226-228 Washington Street

Brighton, Massachusetts Owner: City Realty - Issued for Permit Set: 02/22/2022 Issued for Revision - 06/04/2024

Modifications from the Revision set dated 02/07/2024 included in this drawing set:

BASEMENT PLAN SCALE: 1/4" = 1'-0"

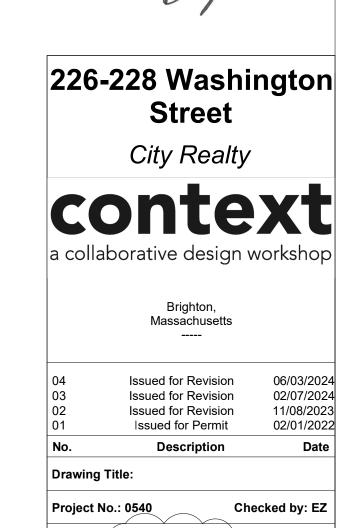
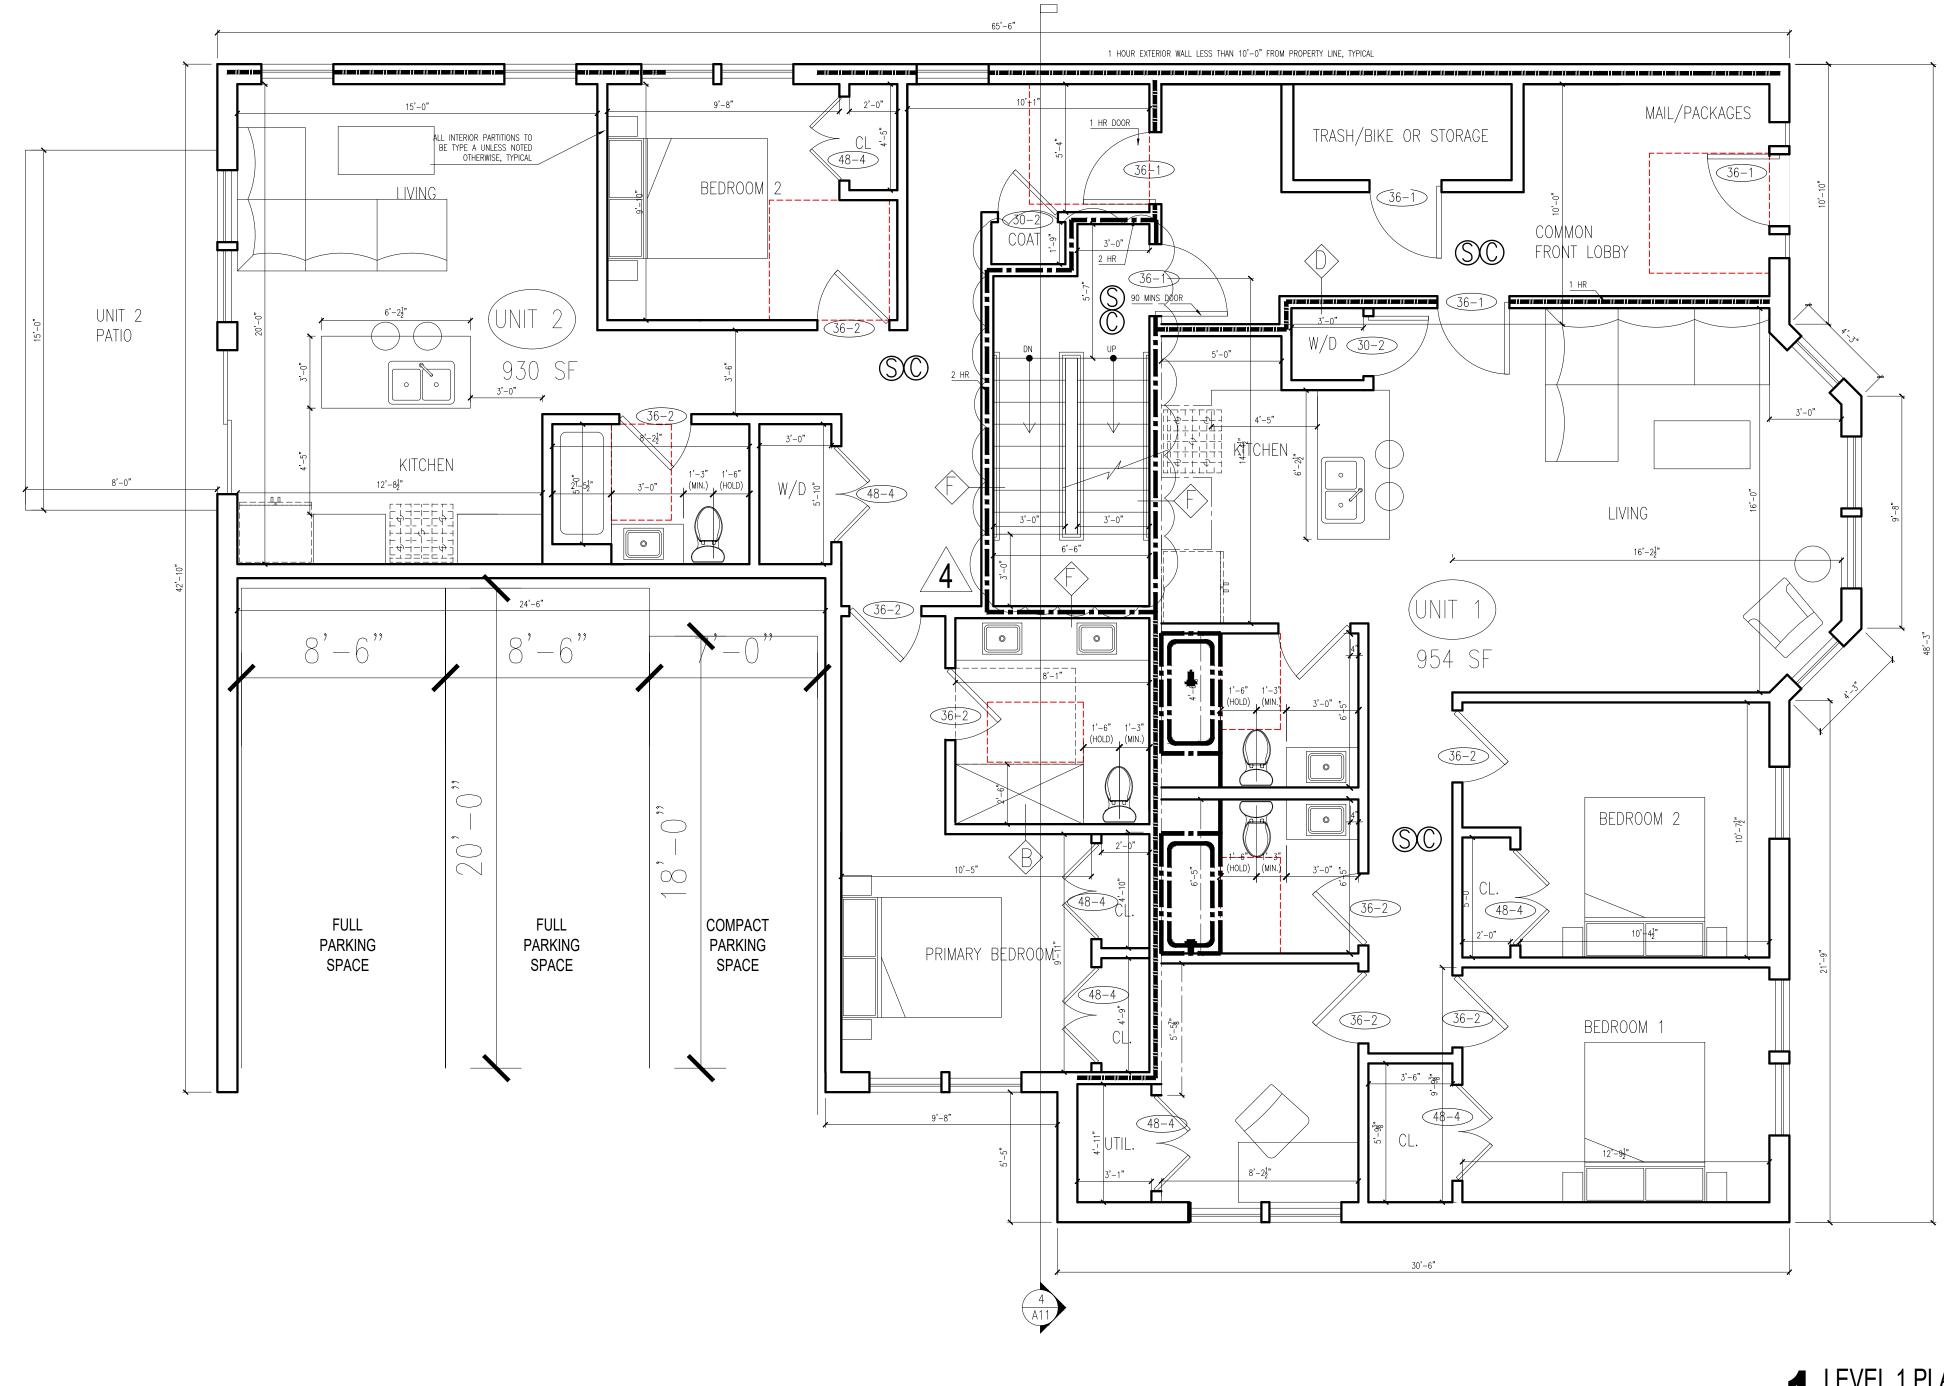
- Interiors stairs reconfigured
- Adding a basement
